Rezoning Application: PD 22-1229
Zoning Hearing Master Date: January 17, 2023
BOCC Land Use Meeting Date: March 7, 2023

The applicant seeks to rezone two parcels from RSC-6 (Residential, Single-Family Conventional) to PD (Planned Development) to allow for the development of 48 two-family attached units.

AGENCY REVIEW COMMENT SHEET

8.0 PROPOSED SITE PLAN (FULL)

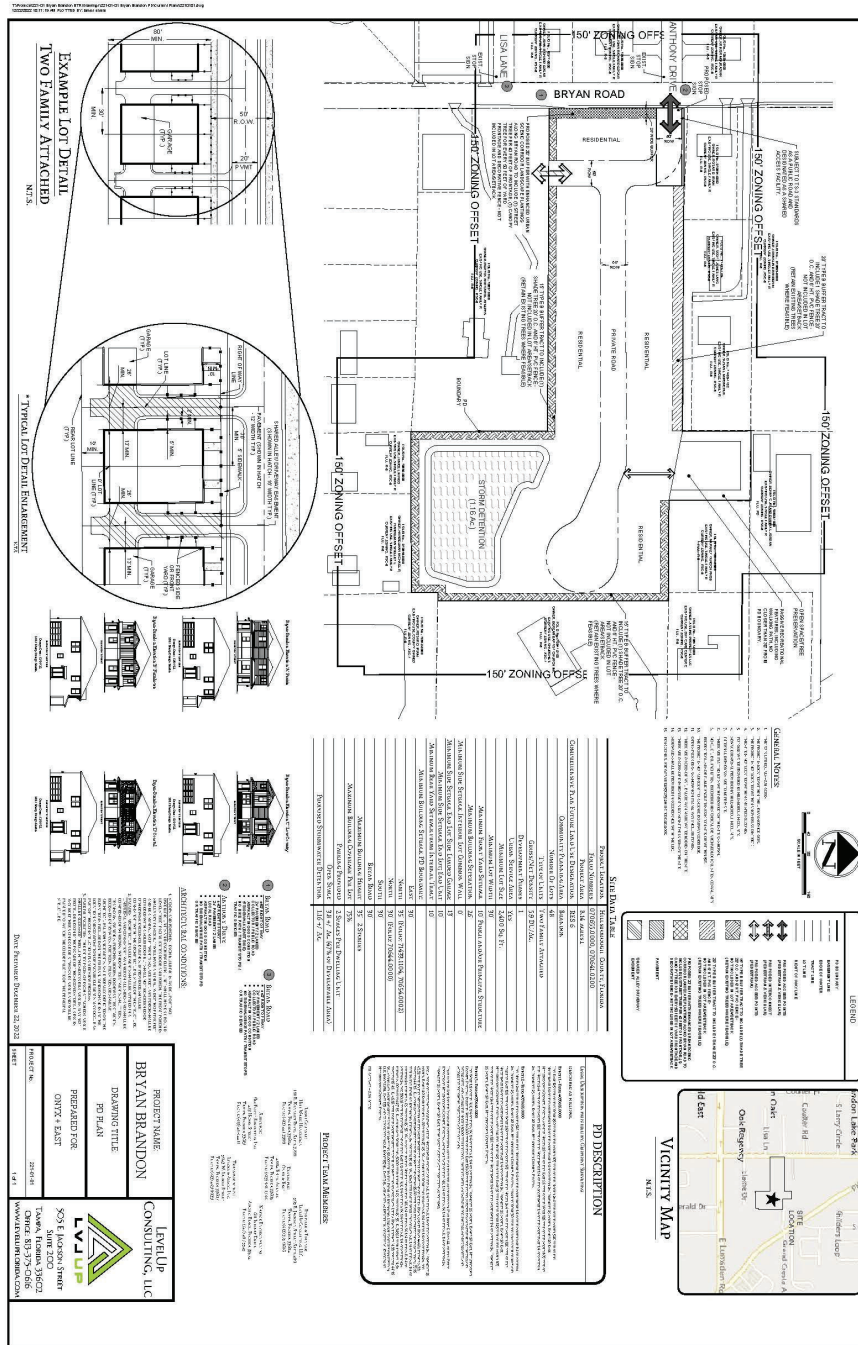
- 1. Site plan to note roadway #3 as Lisa Lane.
2. Site Data Table to revise the front yard setback from '10' Porch and/or Principal Structure' to '10' Porch and Principal Structure.'

3. Site Data Table to revise 'Minimum Building Separation: 26'' to 'Minimum Building Separation: 26' first floor/20' second floor.'
4. Site Data Table to remove 'Maximum Building Coverage Per Lot: 75%.' This exceeds the building envelope when applying the minimum setbacks to the minimum lot size.

5. Architectural Condition #2 to revise the first sentence to state that '...all sides and shall be comprised of one or more of the following....'
6. Architectural Condition #1 to revise the last sentence by removing 'one car garage.' Project is not proposing on-street parking and shared driveway will not provide space for tandem parking.

7. Notation over the elevations to state 'Buildings to be developed in general compliance with the elevations - see conditions of approval.'
8. Shift the shared access facility north in order to be flush with the property line to the north.

DRAWING NO. TS-7	LOCAL & COLLECTOR RURAL ROADS (2 LANE UNDIVIDED) TYPICAL SECTION
SHEET NO. 1 OF 1	
REVISION DATE: 10/17	 Hillsborough County Florida
TRANSPORTATION TECHNICAL MANUAL	22-1229

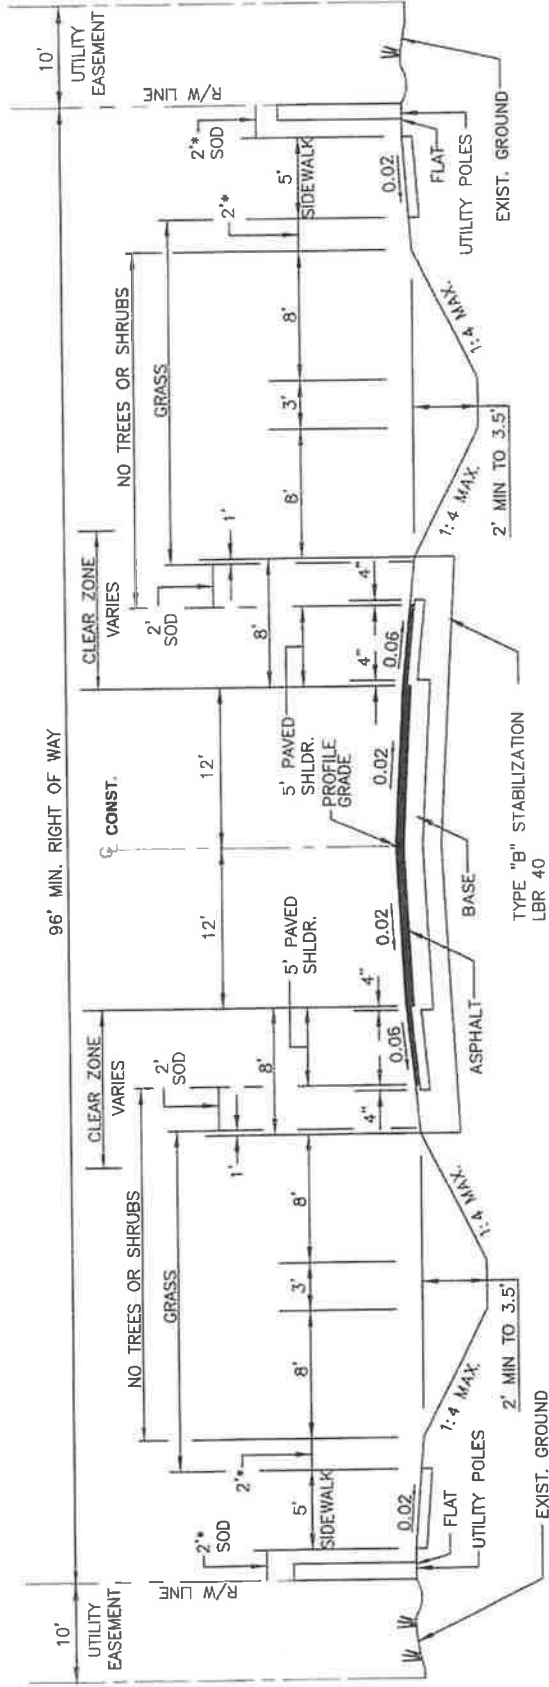
The request is to waive the requirement to improve Bryan Road (between the project access and Lumsden Road) to current County roadway standards, the standards for which are found within the Hillsborough County Transportation Technical Manual.

The variance requested is to the TS-7 standards which are as follows:

1. Right of Way – TS-7 has 96 feet of right of way. There is approximately 50 feet of right of way along the subject segment of the roadway.

2. Lane Width – TS-7 has 12 foot lanes. The existing roadway has 11 foot lanes.
3. Shoulders – TS-7 has 8 feet shoulders with 5 feet paved. There are limited shoulders along the road.
4. Sidewalk – TS-7 has 5 feet sidewalk on both sides of the roadway. There is sidewalk on the east side of the roadway along the subject segment of the roadway.

I have found the attached Section 6.04.02.B. Administrative Variance (AV) for PD 22-1229 APPROVABLE.
